SSD Submission Response

UNSW - Biological Sciences Project
May 21, 2015

prepared for Brookfield Multiplex
by Black Beetle pty ltd

PROJECT
Biological Sciences Renewal Project
UNSW
KENSINGTON NSW
DRAWING TITLE
West Entry - General Arrangement Plan

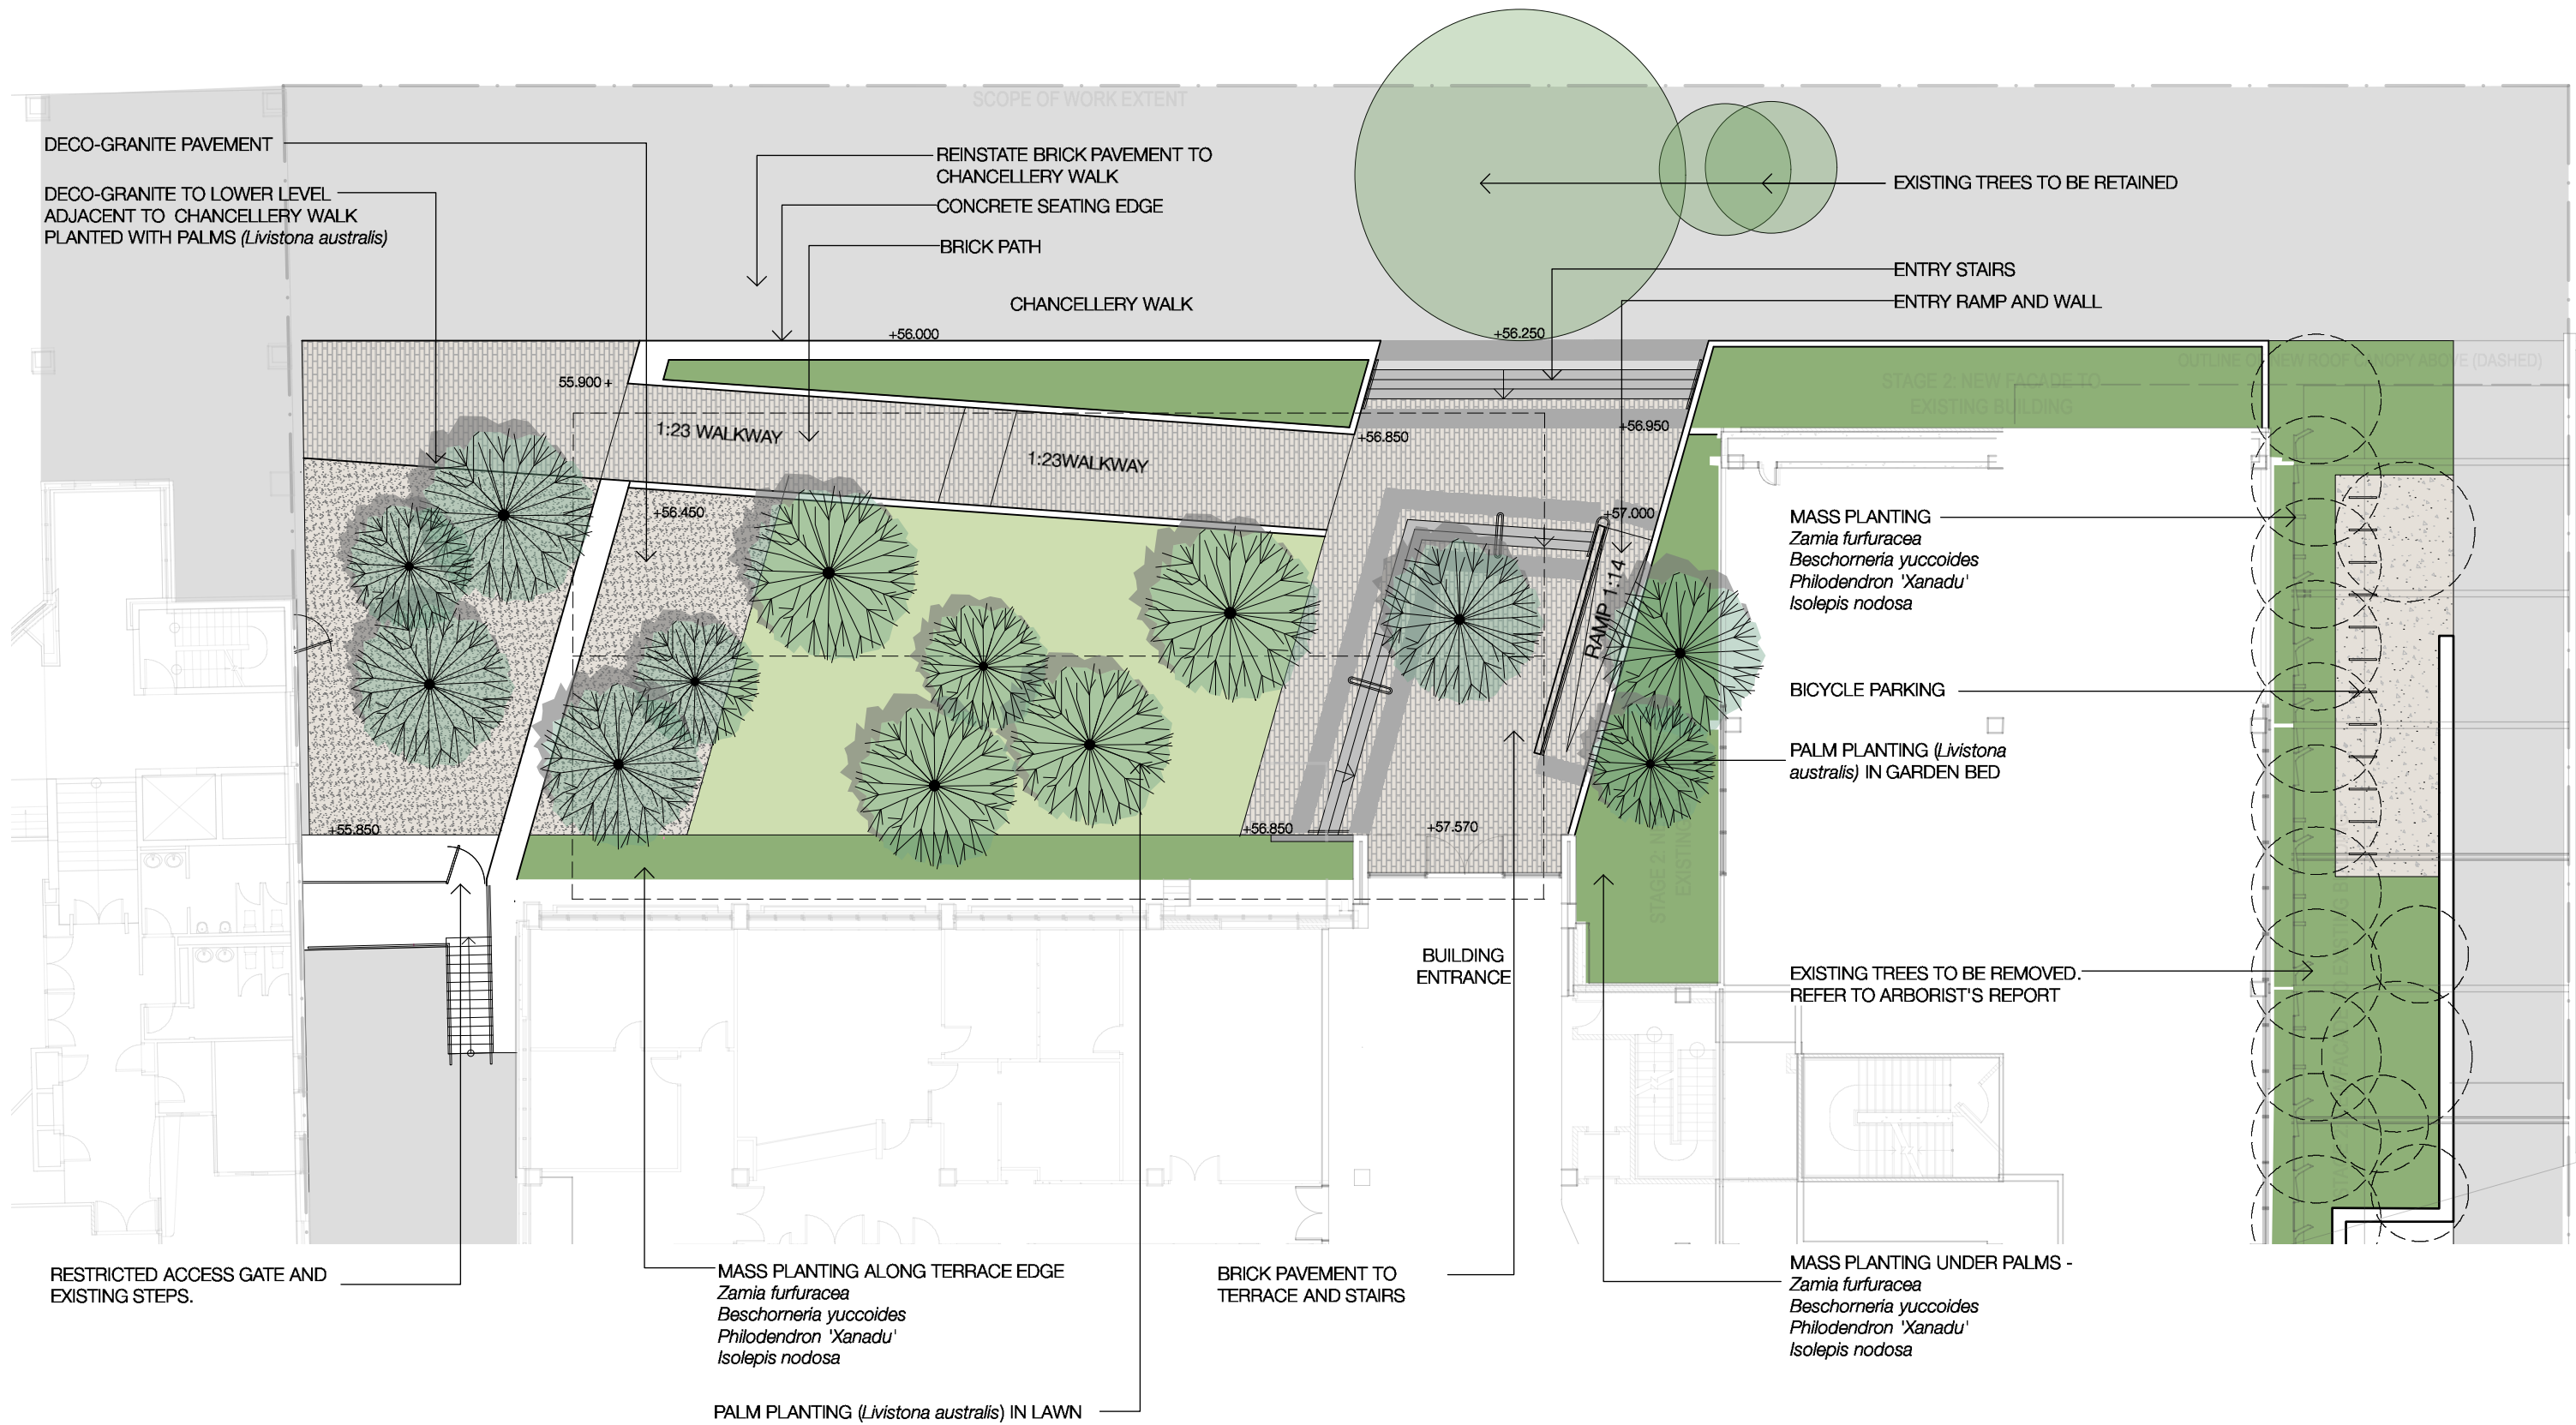
CP02 changes as follows:

- entrance ramp to BioScience building widened to 3m.
